STAFF RECOMMENDATION
3930 Cambridge Avenue
December 19, 2018

Application: New Construction—Outbuilding/ Detached Accessory Dwelling Unit (DADU)

District: Cherokee Park Neighborhood Conservation Zoning Overlay

Description of Project: The current application is for new construction of a detached accessory dwelling unit (DADU) at the rear of the lot.

Site Planning & Setbacks:

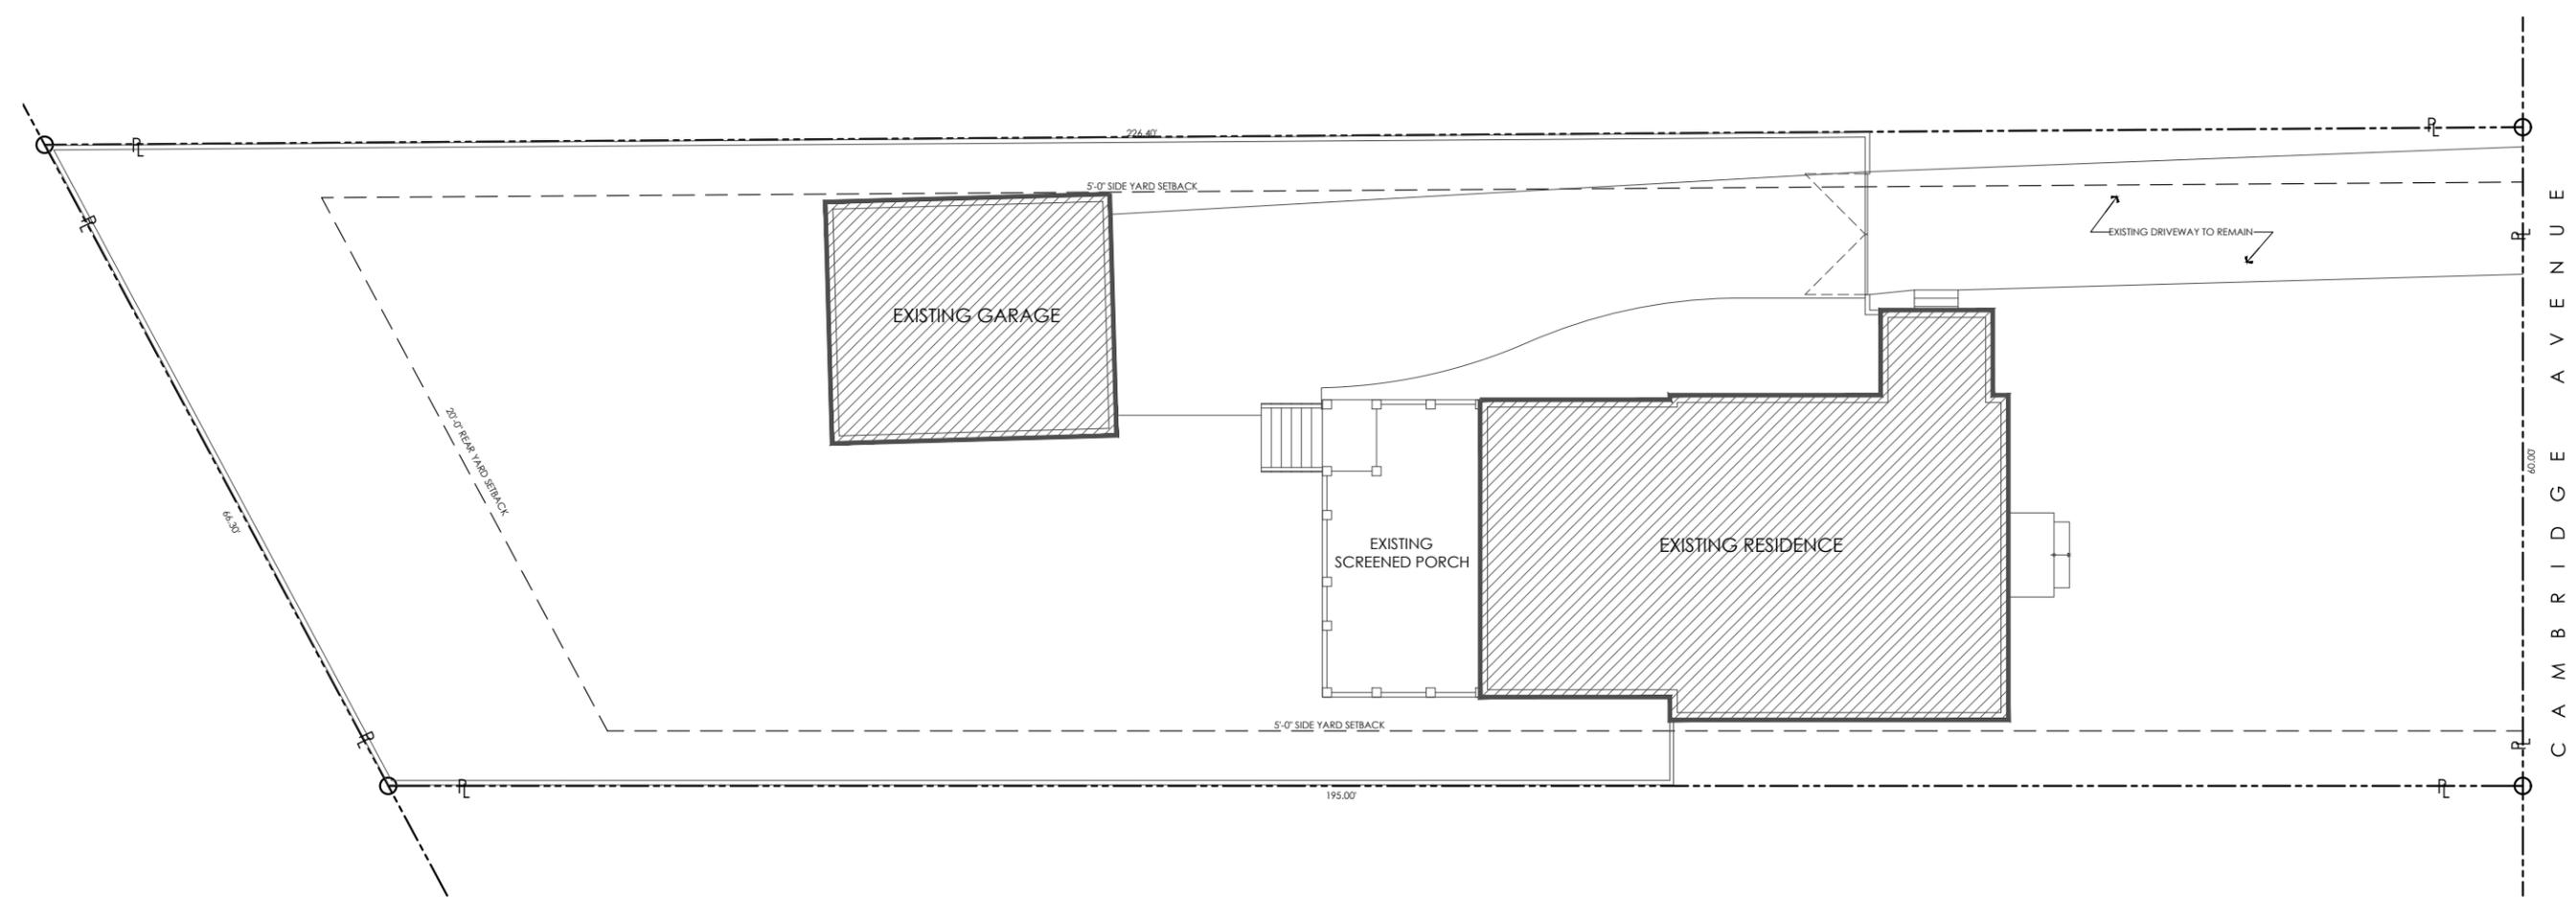
MINIMUM	PROPOSED
Building located towards rear of lot	-	Yes
Space between principal building and garage	20'	52'
Rear setback	5'	5'
Left side setback	5'	5'
Right side setback	5'	21'
How is the building accessed?	-	Existing driveway
Two different doors rather than one large door (if street facing)?	-	N/A

The project meets all base zoning setback requirements.

DATE OF ISSUANCE:
03 December 2018
PROPOSED FRONT + SIDE
ELEVATIONS

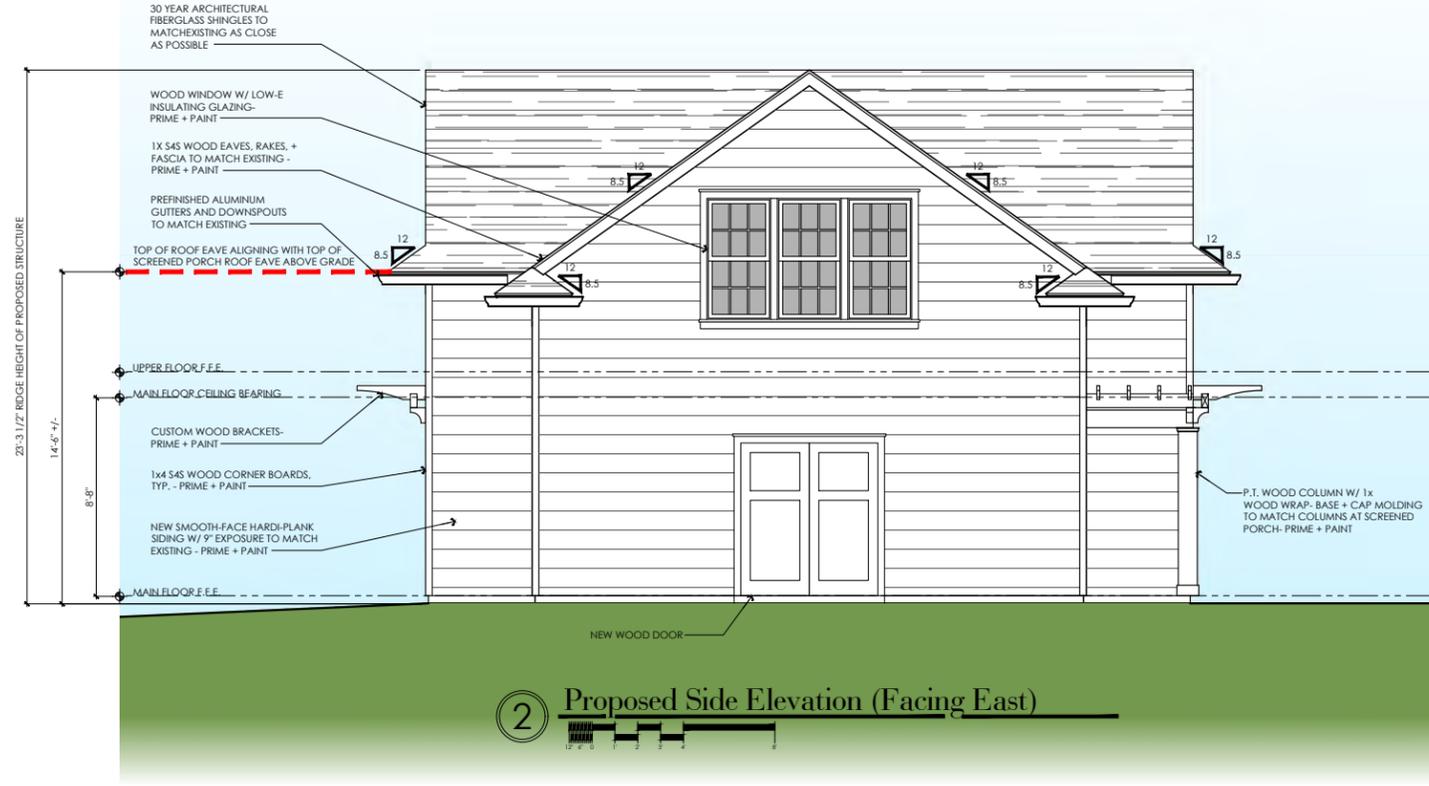
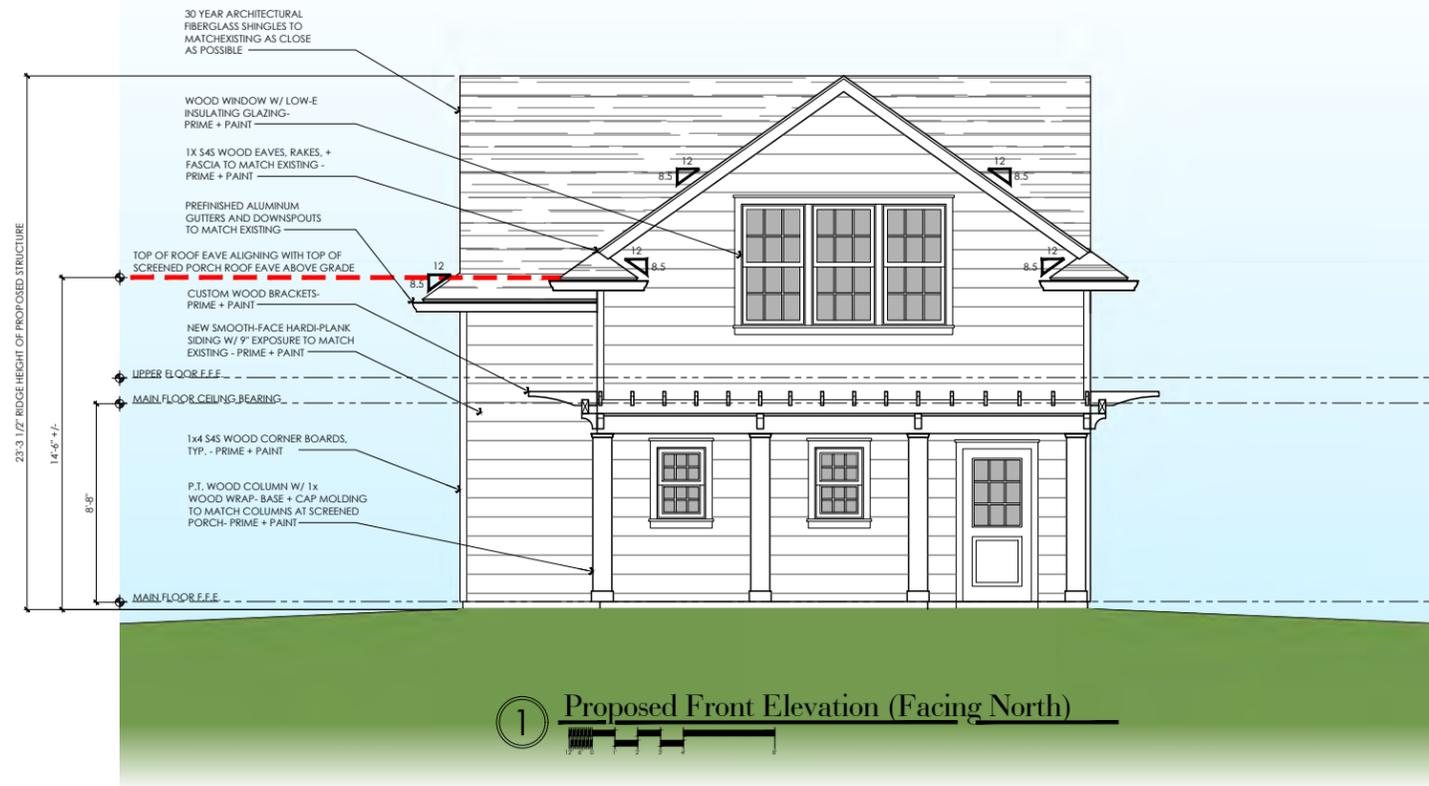
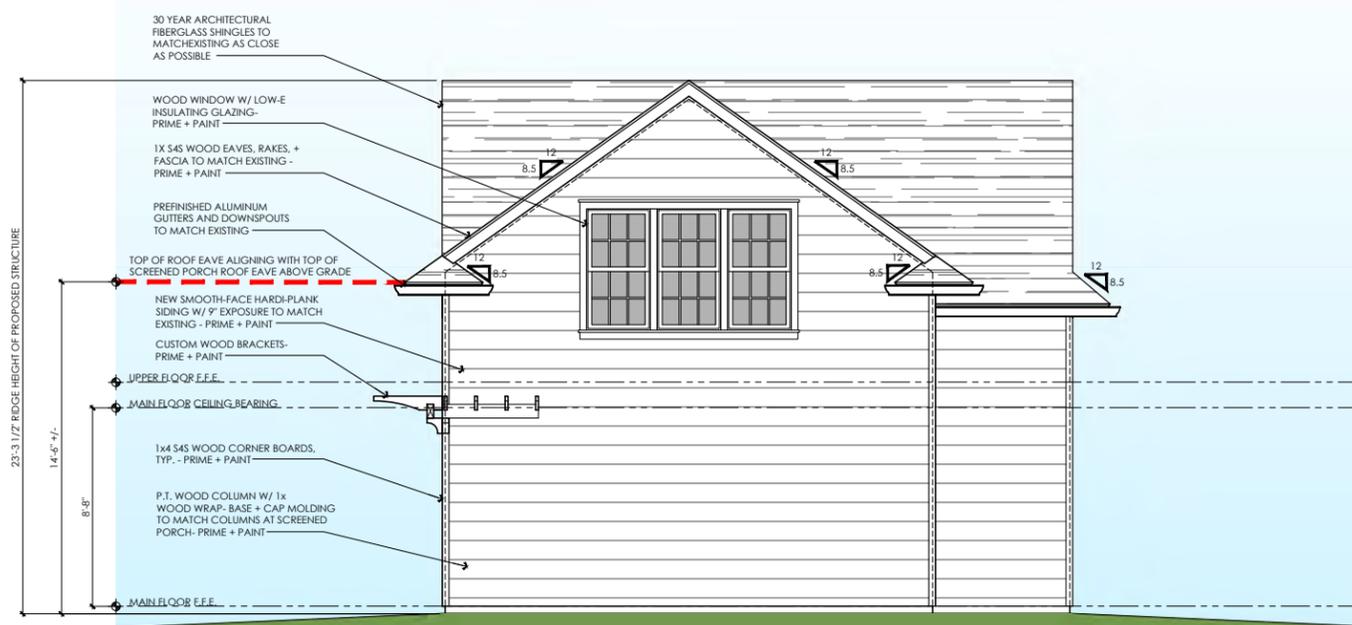
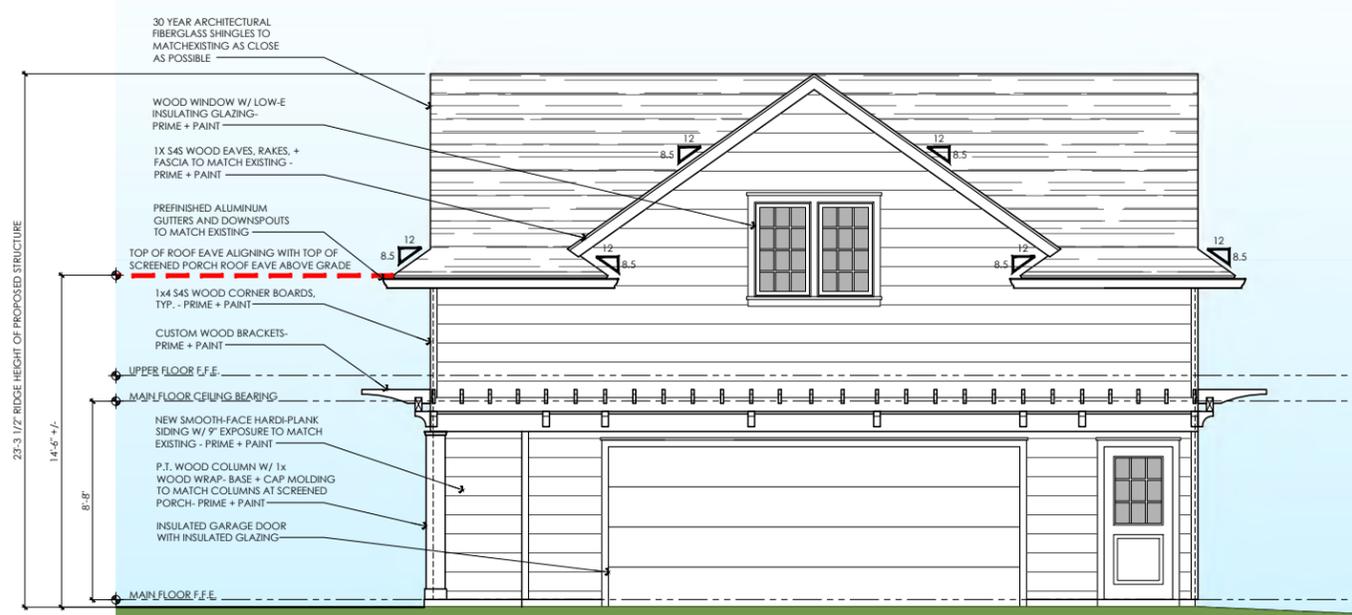
Potential maximums under Ordinance	Existing House	Proposed DADU
Ridge Height	25' unless existing building is less	26'	22'
Eave Height	10'	12'	14'6"

twenty-two foot (22') height is subordinate to the twenty-six foot (26') ridge height of the house and is under the maximum height allowed. However the proposed eave height of fourteen feet, six inches (14' 6") exceeds the eave height of the house. The house's eave height averages twelve feet (12'). Section III.B.2.h.1 of the design guidelines and 17.16.030.G.7 of the Ordinance for DADUs require that a DADU's eave height be subordinate to house's eave height, with a ten-foot (10') maximum for a one-story outbuilding, or seventeen feet (17') for a two-story outbuilding. In this case, a two-story outbuilding would not be subordinate to the house; therefore the eave height is restricted to ten feet (10').

Staff recommends that the outbuilding's eave height be reduced to no more than ten feet (10') in order to meet the design guidelines Section III.B.2.h.1, and Section 17.16.030.G.7 of the DADU Ordinance for height and scale.

1. The eave height is reduced to ten feet (10’); and,
2. Staff approve the roof color, windows and doors prior to purchase and installation.
